SITE PLAN REVIEW AND APPEARANCE BOARD STAFF REPORT

Delray Bungalows Restaurant

Meeting	File No.	Application Type
May 27, 2026	2023-018-SPF-SPR	Level 2 Site Plan with Landscape Waiver and Determination of Adequacy
Property Owner	Authorized Agent	
25 SE 3rd Avenue, LLC	Joseph A. Ruiz

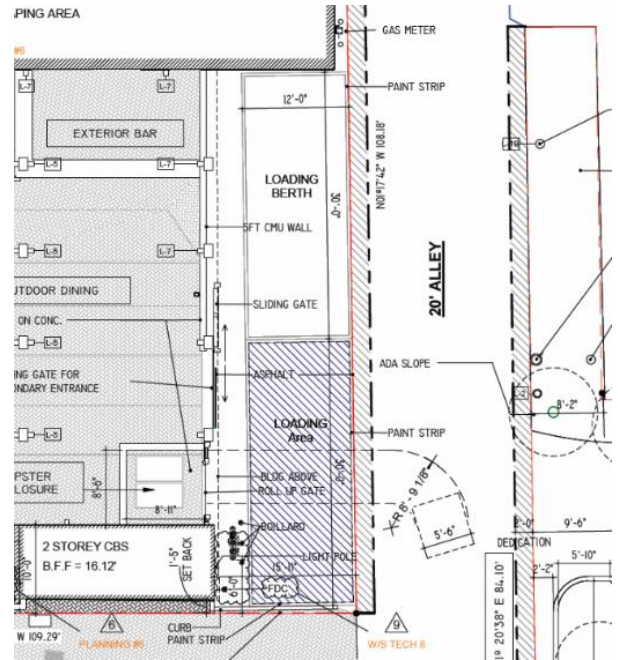
The applicant requests a determination of adequacy to permit the provision of one loading space for the restaurant located at 25-27 SE 3rd Avenue. Pursuant to LDR Section 4.6.10, restaurants between 10,000 and 20,000 square feet are required to provide two off-street loading spaces. For purposes of the loading review, the proposed restaurant has been evaluated at 10,811 square feet, inclusive of the existing 8,379-square-foot building and the 2,432-square-foot covered outdoor dining area. Based on this calculation, two loading berths are required.

The applicant proposes one loading berth with a loading area located at the rear of the property with access provided via the alley. The proposed loading space meets the minimum dimensional standards of the regulations. The rear location of the loading space and alley access reduces conflicts with pedestrians and primary street frontages while allowing delivery and service vehicles to operate off the main roadway, thereby reducing impacts to traffic circulation and on-street parking. The project is also located near the lower threshold of the 10,000 to 20,000 square foot loading category, and the applicant has indicated that one loading berth is sufficient to serve the operational needs of the proposed single-tenant restaurant use.

The Board shall determine whether the proposed one loading berth satisfies the intent of LDR Section 4.6.10 and is adequate to serve the proposed restaurant use within the existing downtown context. In making this determination, the Board may consider the size and character of the use, the adaptive reuse of the existing building, the rear alley access, the location of service functions, the relationship to pedestrian areas and public frontages, and whether the proposed loading arrangement is sufficient to avoid adverse impacts on alley circulation, vehicular circulation, solid waste collection, fire access, accessible routes, and surrounding properties.

Images of the proposed and existing elevations are provided below.

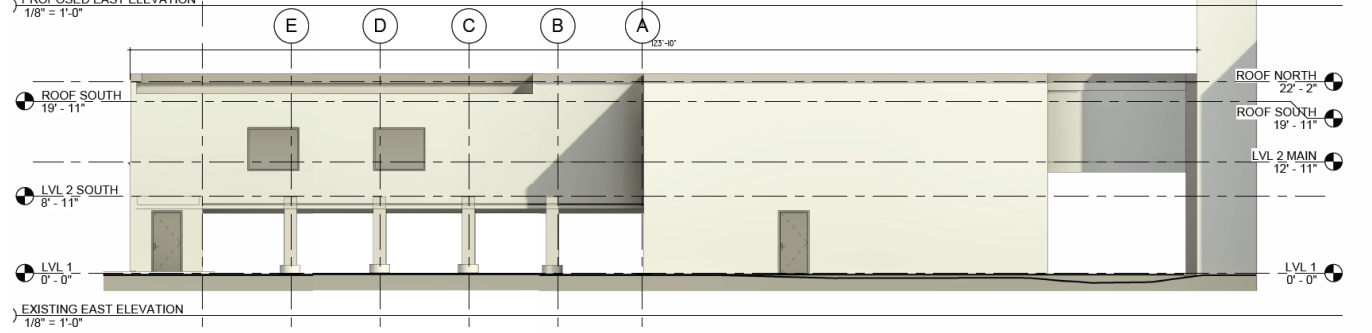
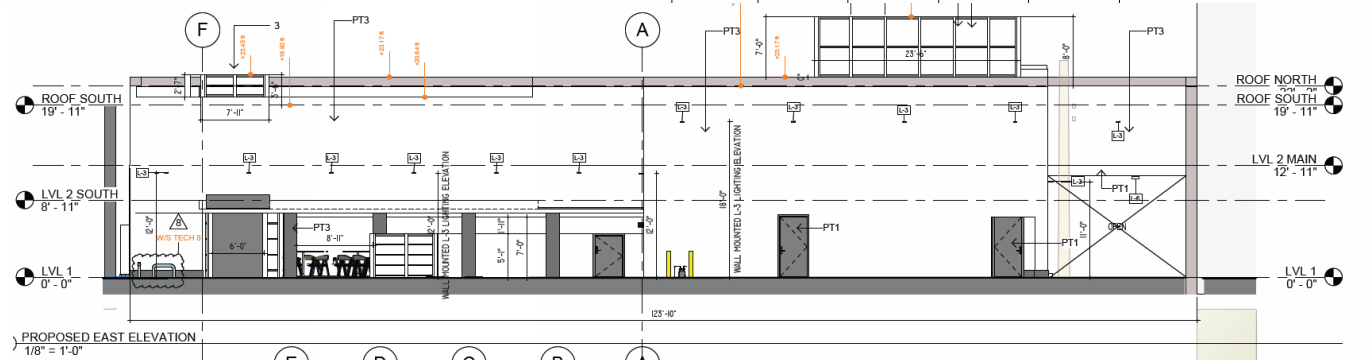
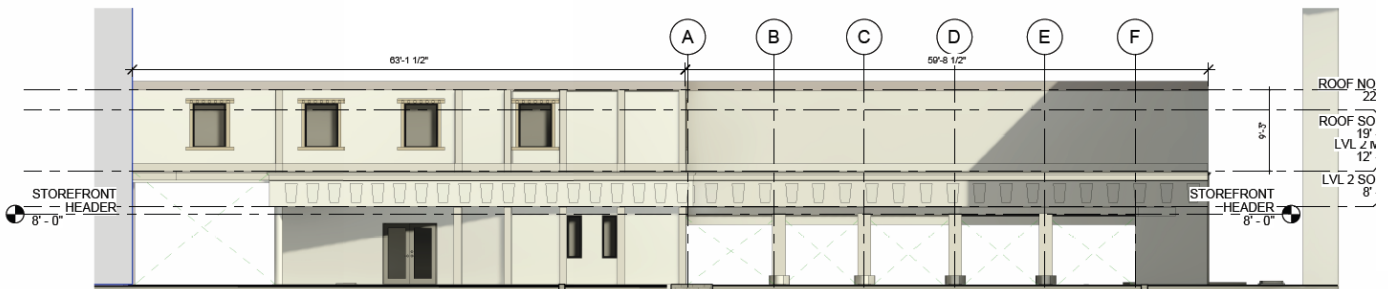
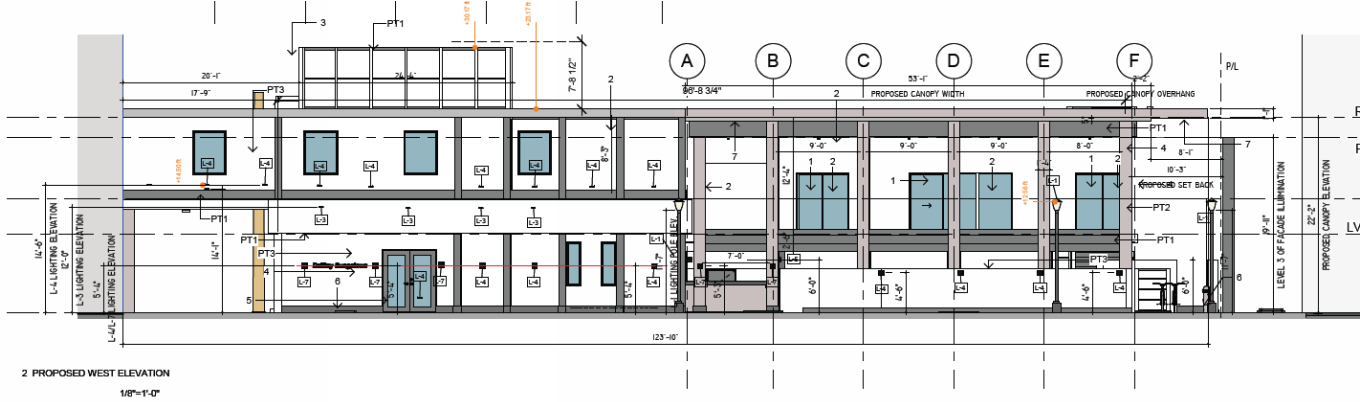
The proposed elevation modification reconfigures the former drive-thru side of the building to support a pedestrian-oriented restaurant use while retaining the primary two-story building massing and upper-level architectural character. The modifications include the removal and replacement of drive-thru elements such as the teller lanes with a newly covered outdoor dining area. The vehicular service function is eliminated and replaced with pedestrian focused activity along the façade. The canopy is supported by a rhythm of vertical columns that establish a strong architectural bay spacing, while also providing weather protection for patrons. The existing west elevation features a prominent horizontal decorative band, in line with a classical traditional style, that transitions between the first and second floors; as part of the renovation, the decorative banding is proposed to be replaced with a minimal banding that still serves as a strong visual datum that reinforces the building's original institutional character while aligning with the proposed Masonry Modern style, integrating the new outdoor dining area, and emphasizing the column rhythm into a cohesive ground-floor composition.

LDR 4.4.13(F)(2) - Façade Composition, Tripartite Organization: The design is superimposed on the existing façade, still maintaining a clear division of base, middle and top façade composition. The base consists of the ground floor, the top is defined by the second floor and the overhang cantilevered over the outdoor dining area, and the middle is comprised of the raised stucco and column support that cuts through the front façade.

LDR 4.4.13(F)(3) - Architectural Style, Masonry Modern: The proposed west elevation introduces architectural elements consistent with a modern interpretation encouraged by the CBD guidelines. The updated façade simplifies and removes the heavier ornamental banding, replacing it with a cleaner horizontal and vertical expression, larger uninterrupted wall planes, and a more restrained material palette. These changes emphasize contemporary proportions, reduced ornamentation, and a clearer façade hierarchy, which aligns with the CBD guidance promoting modern design that is compatible with the district through high-quality materials, articulated massing, and a simplified, cohesive architectural composition.

LDR 4.4.13(F)(4) - Walls and Primary Materials: The proposed material palette supports a modern architectural expression through a restrained and cohesive use of finishes. The façade is proposed in a matte white, creating a clean, high-contrast composition that emphasizes simple forms and shadow lines. The canopy incorporates aluminum composite paneling at the upper fascia, introducing a sleek and durable material commonly associated with modern commercial architecture. Together, the limited color palette and use of contemporary cladding materials reinforce a modern aesthetic consistent with the CBD architectural guidance promoting high-quality, durable materials and a unified façade composition.

LDR 4.4.13(F)(5) – Openings and Transparency: The proposed elevation increases transparency through the introduction of new window openings at the second floor, replacing portions of the previously solid wall areas. These additional windows create a more balanced and rhythmic fenestration pattern, improved natural light to interior spaces, and reduce the visual heaviness of the upper façade. The enhanced fenestration supports CBD architectural guidance encouraging well-articulated façade with increased glazing and improved visual interest while maintaining compatibility with the buildings overall composition.

LDR 4.4.13(F)(6) - Roof Form and Screening: The proposal maintains the existing flat form while incorporating rooftop mechanical equipment screening. New air condition units will be enclosed by an approximately eight-foot tall decorative screen designed to integrate with the building's architecture. The screening will minimize the visibility of mechanical equipment from surrounding public rights-of-way and adjacent properties, supporting CBD guidance that rooftop equipment be fully screened and visually integrated into the overall building design.

LDR 4.4.13(F)(7) - Architectural Elements: Architectural detailing includes a cantilevered projection for solar shading over the outdoor dining area, smooth stucco, and vertical architectural elements reinforcing an asymmetrical relationship with the existing structure and the carved dining space. Structural expression elements contribute to façade depth and architectural interest consistent with CBD Architectural Guidelines and the selected architectural style. The recessed area has the potential to be further highlighted with a change in material as depicted in the proposed rendering. The Board should consider if the design should incorporate the change of material for the recessed area, further emphasizing the carved space, or maintain the current color palette throughout the design.

Overall, the adaptive reuse converts a vacant former bank building into a modern restaurant with a substantial outdoor dining area. The proposed design utilizes Masonry Modern elements intended to improve the building's visual quality while maintaining compatibility with the architectural expectations of the downtown Central Business District. The proposed frontage improvements also support a more

pedestrian-oriented condition along SE 3rd Avenue. The Board shall determine whether the architectural elevations are consistent with LDR Section 4.4.13(F), LDR Section 4.6.18, and the applicable CBD design standards.

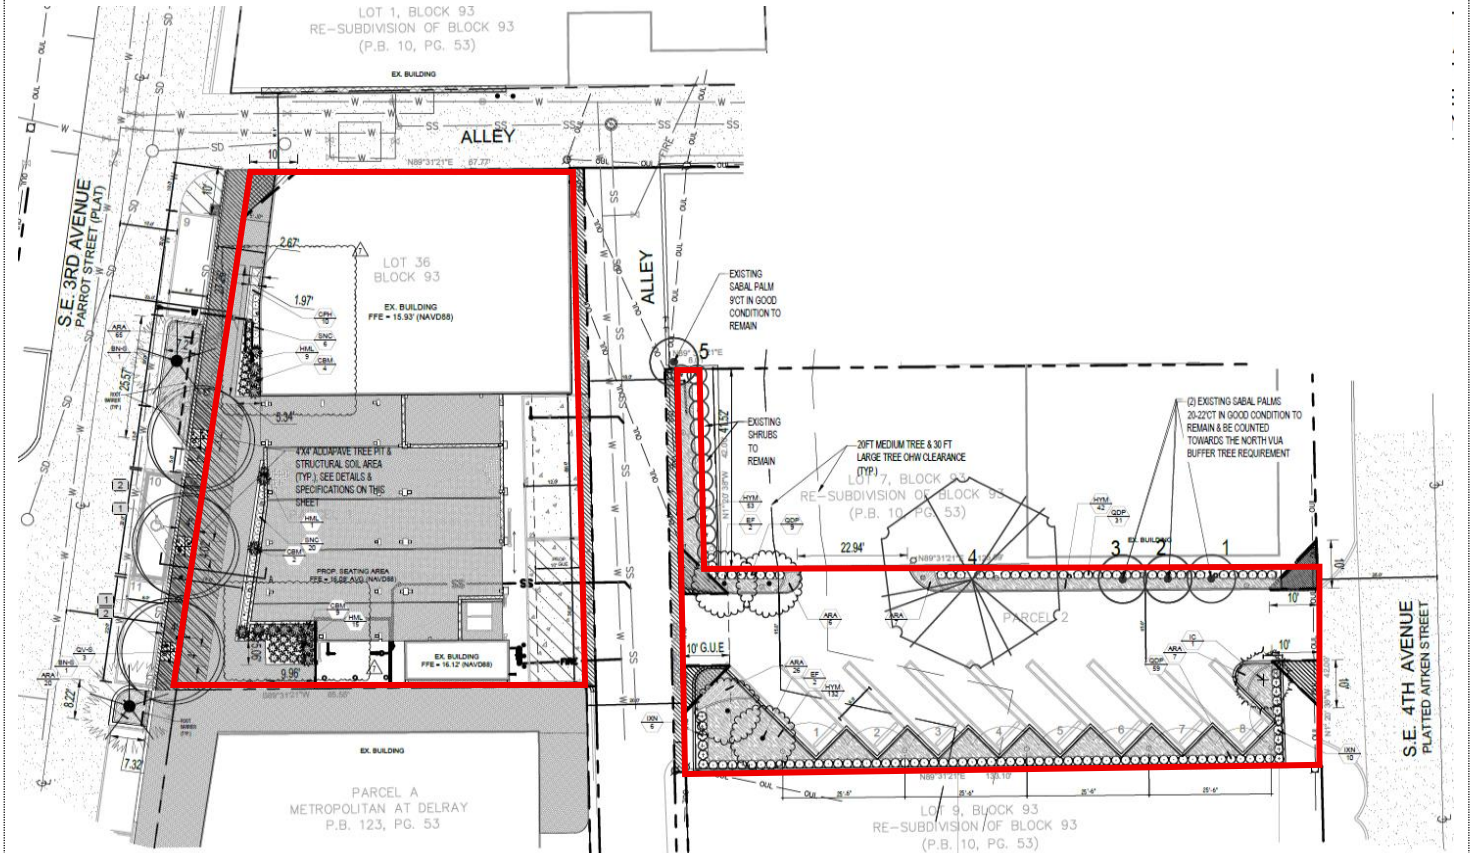
The landscape plan reflects a comprehensive reconfiguration of the site circulation, parking layout, and streetscape improvements to better integrate vehicular access, pedestrian connectivity, and required landscape buffering. The existing parking area along the eastern portion of the site has been redesigned to incorporate a series of angled parking spaces oriented along the internal drive aisle, improving maneuverability and maximizing the number of spaces within the available footprint. This reconfiguration introduces a continuous landscape edge and interior planting areas, including a defined landscape island and perimeter planting strip that provide shade, visual buffering, and compliance with landscape coverage standards. Along the western frontage, new street trees and continuous foundation planting have been added to establish a formal streetscape edge and strengthen the pedestrian realm. The plan also identifies existing Sabal Palms to remain and be credited toward buffer requirements, supplemented with new shrubs and canopy trees to create a layered planting scheme. Additional landscape notes clarify installation standards, irrigation coverage, and a requested waiver related to landscape island width, ensuring the design intent is clearly documented and aligned with the applicable code requirements while enhancing the overall appearance and function of the streetscape.

Overall, the landscape design improves the existing condition by adding street trees, foundation planting, perimeter landscaping, and parking-area landscaping where site dimensions allow. The proposed landscape improvements support the pedestrian frontage and provide partial visual buffering of vehicular use areas. The Board shall determine whether the landscape plan, together with the requested landscape waiver, is consistent with the applicable requirements and intent of LDR Section 4.6.16.
